ADDENDUM #6

Subj: Addendum #6 to **BPA-RFQ23-ISLAND (CONSTRUCTION OF A CONCRETE ISLAND AT MAYOR BILL CARPENTER PARKING GARAGE)**

Date: September 25, 2023

DRAWING NO.
PK-2

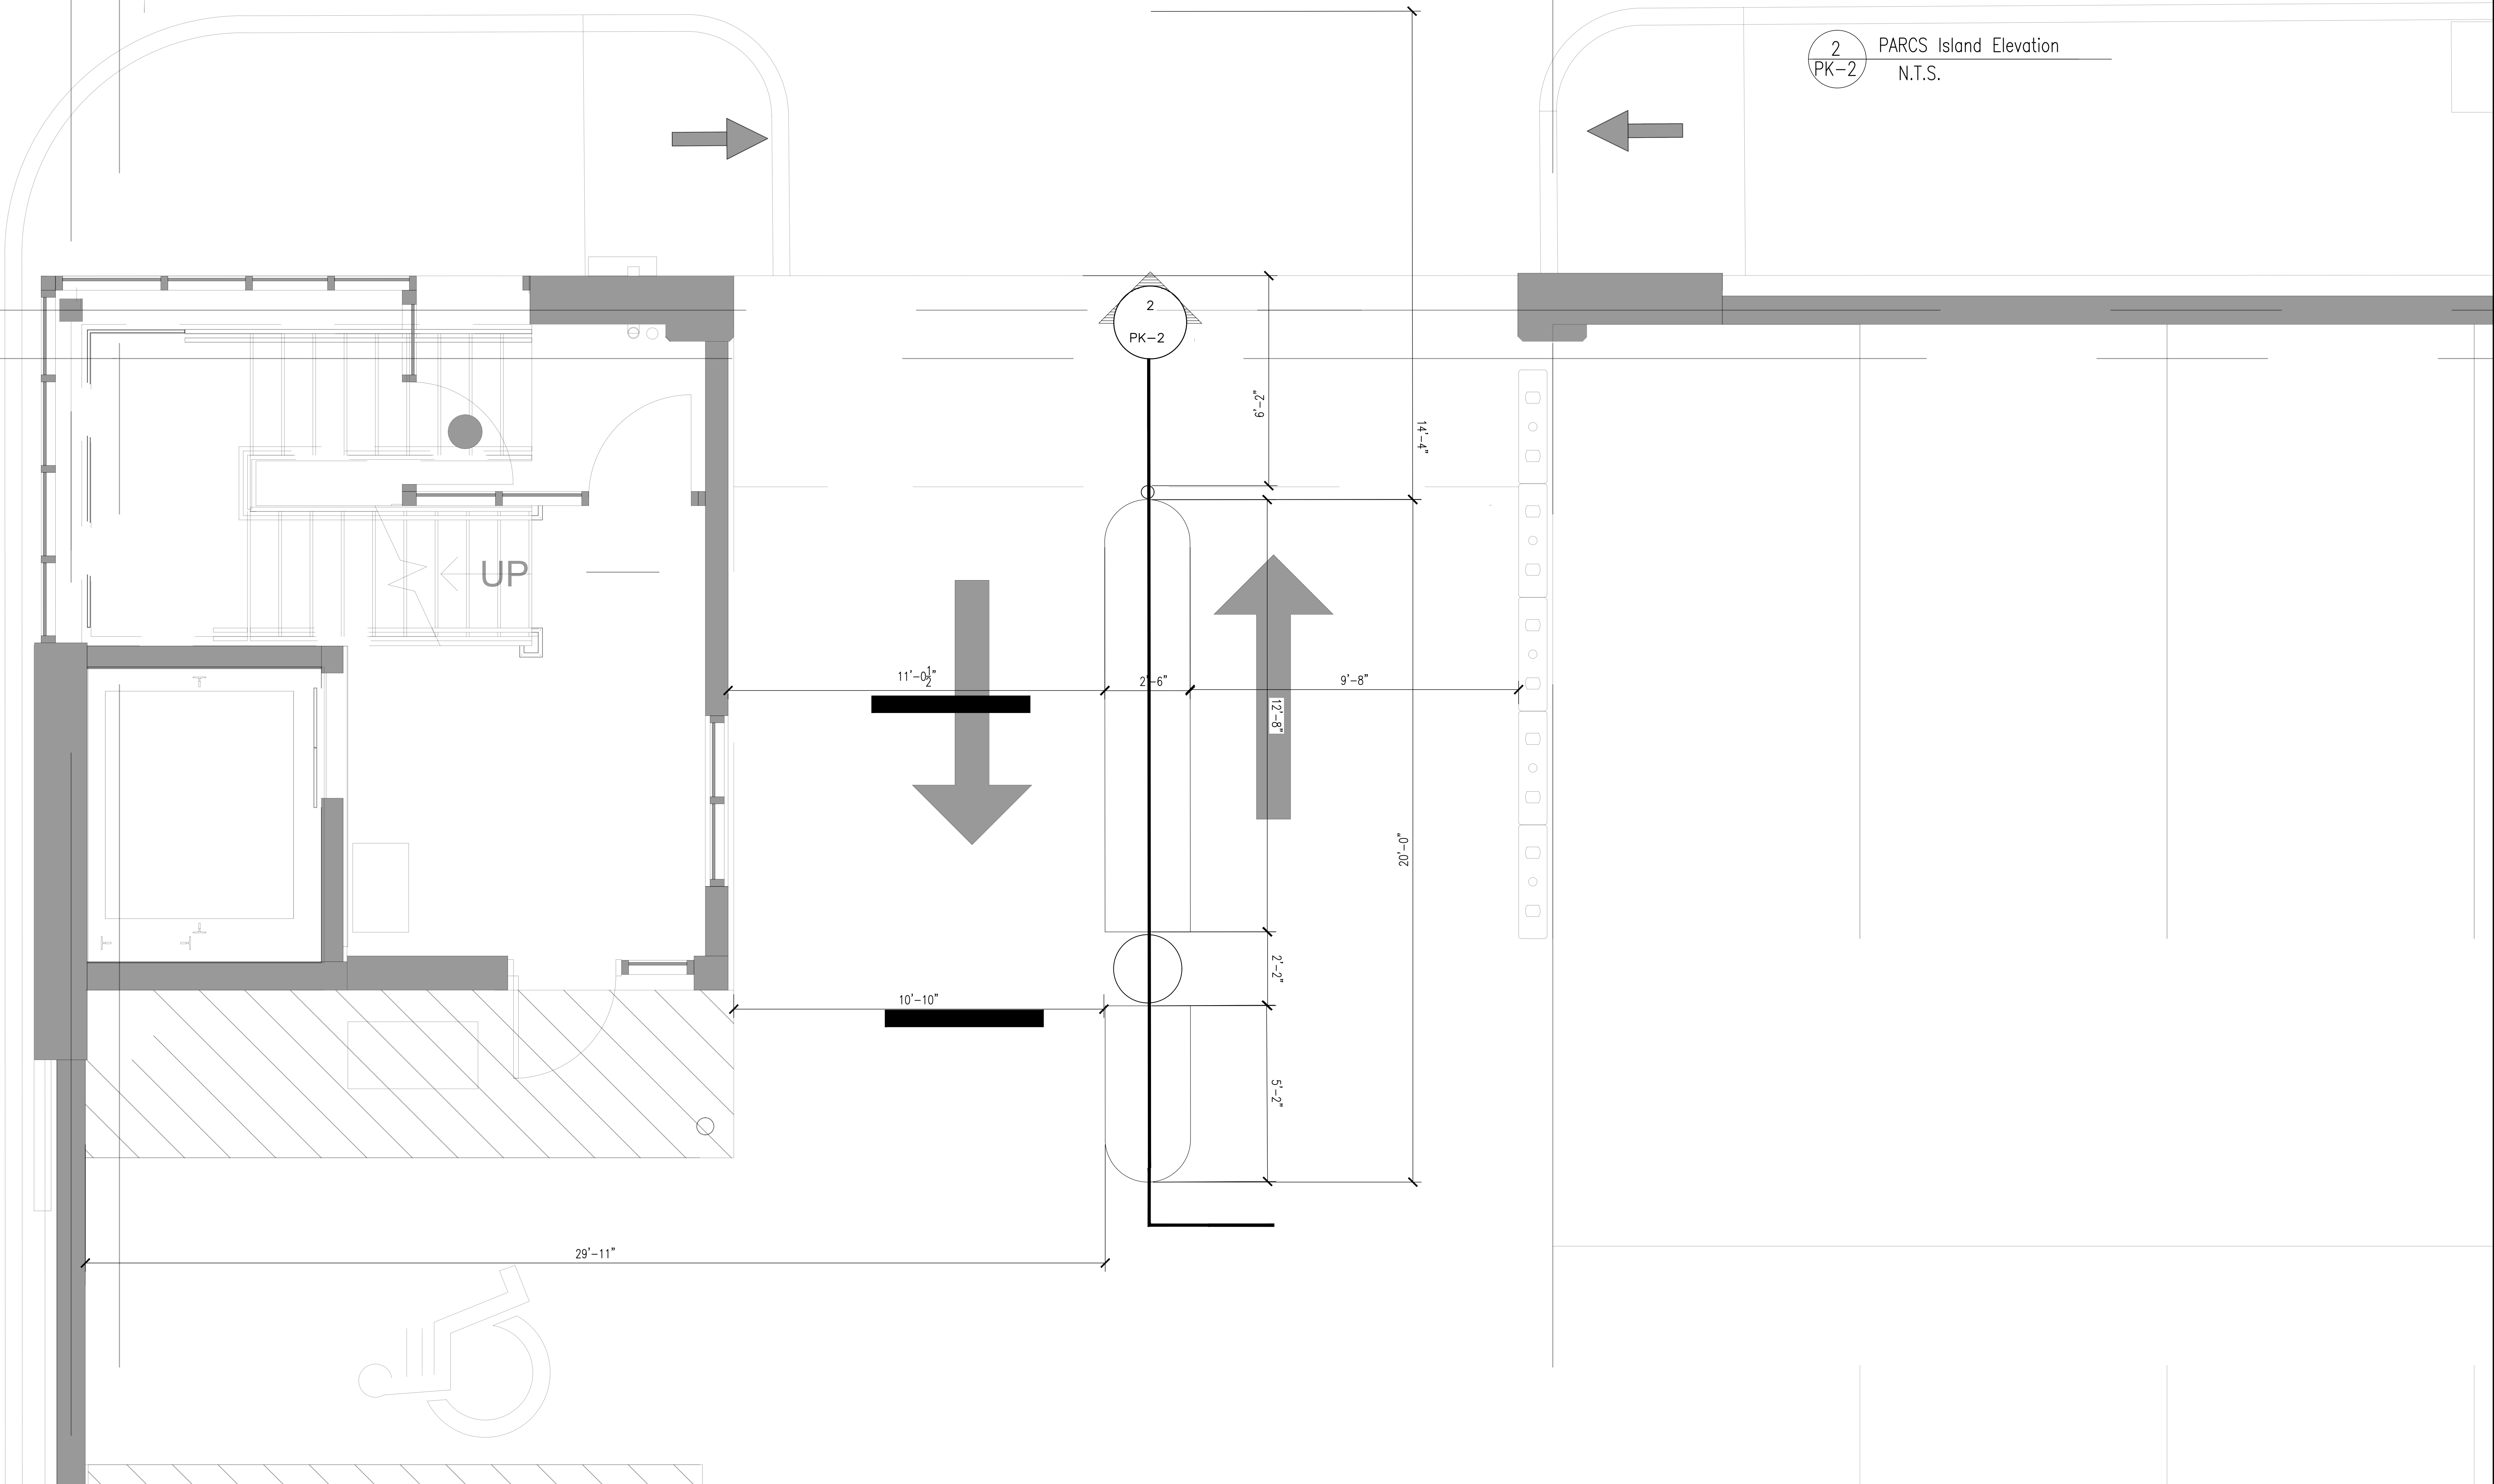
Please note the modified drawings attached which show proper orientation within and dimensions for the island reflective of the existing location of castings for the oil/water separator and drain cleanouts.

2. Are the casting [for the drain clean] and box [for the water/oil separator] to be raised or boxed out?

Answer: As shown on the attached amended drawings, the castings for both the drain clean-out and water/oil separator are to be essentially 'boxed out' where in the island will be poured around these obstructions and the island are located in the lane in such a manner that neither casting will be occluded by the island.

Answer: The castings will be "boxed out" as described above, not raised.
